17TH AVENUE
17TH AVENUE

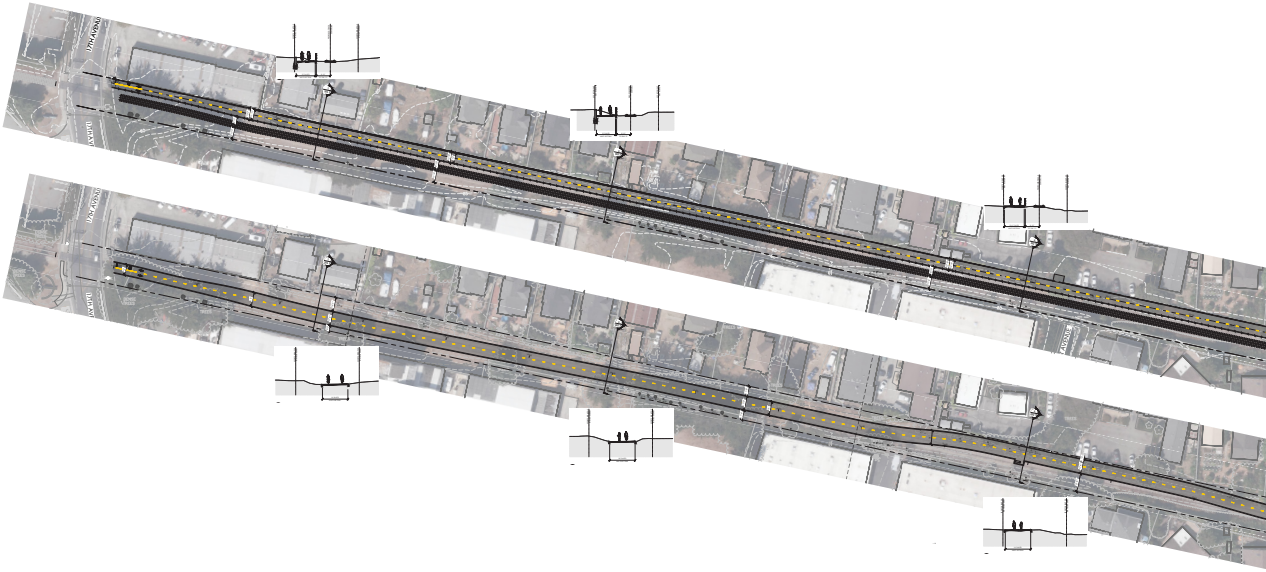
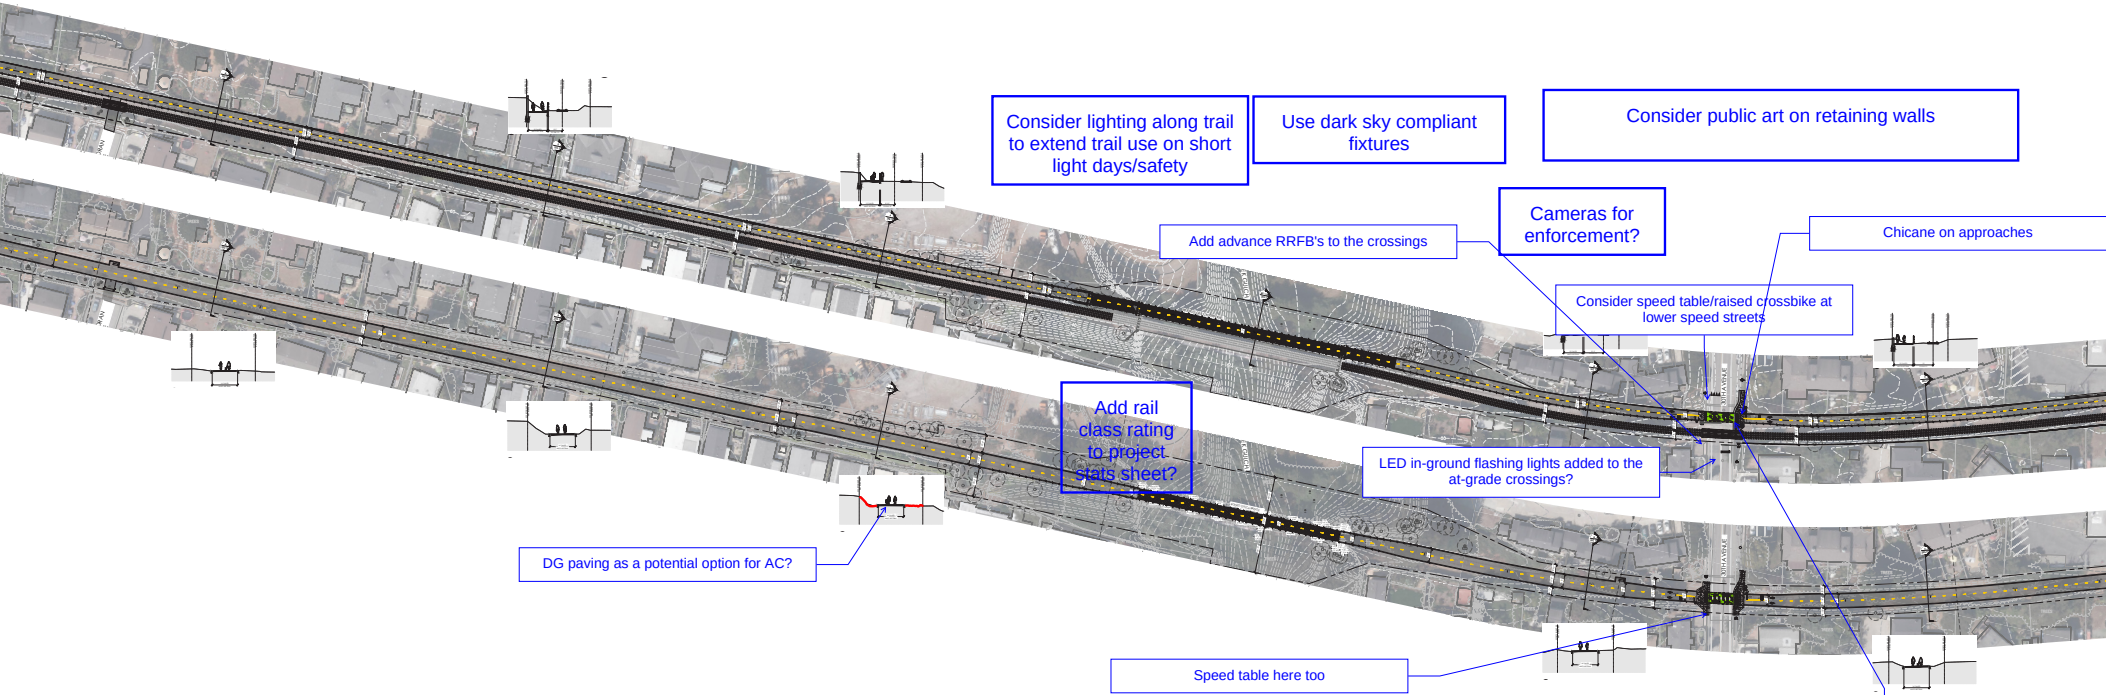
Consider lighting along trail to extend trail use on short light days/safety

Use dark sky compliant fixtures

Consider public art on retaining walls

Cameras for enforcement?

Add advance RRFB's to the crossings

Chicane on approaches

Consider speed table/raised crossbike at lower speed streets

Add rail class rating to project stats sheet?

LED in-ground flashing lights added to the at-grade crossings?

DG paving as a potential option for AC?

Speed table here too

Consider stop signed at each at-grade crossings

JADE STREET PARK
47TH AVENUE
PORTOLA DRIVE
JADE STREET PARK
47TH AVENUE
PORTOLA DRIVE

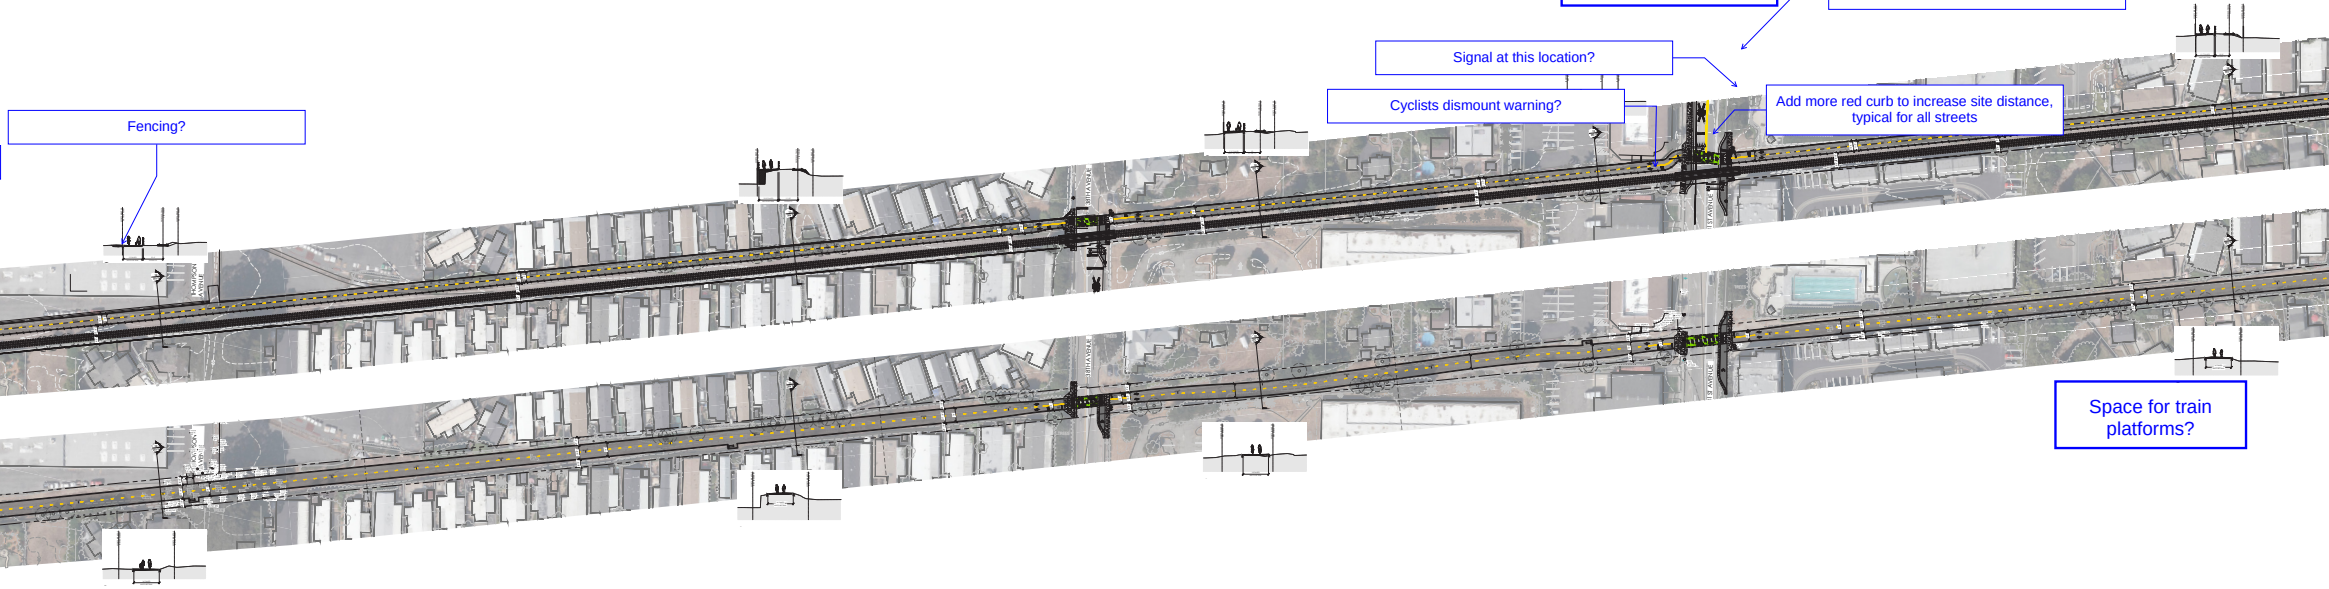
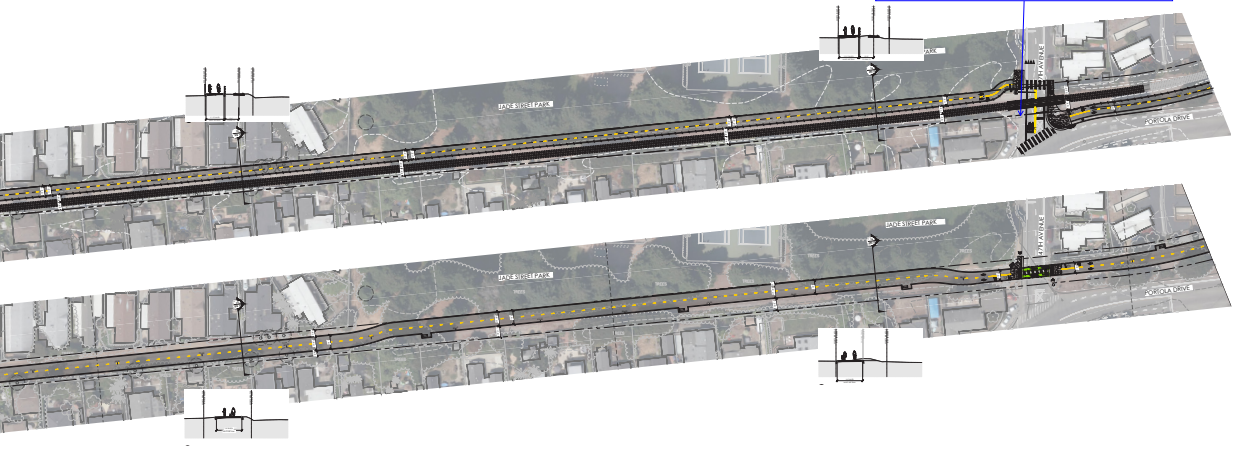
Consider eliminating the existing crosswalk at the Melton.

Audible crossings

Signal at this location?

Cyclists dismount warning?

Add more red curb to increase site distance, typical for all streets

Fencing?

Space for train platforms?

Check stacking distance SB 47th
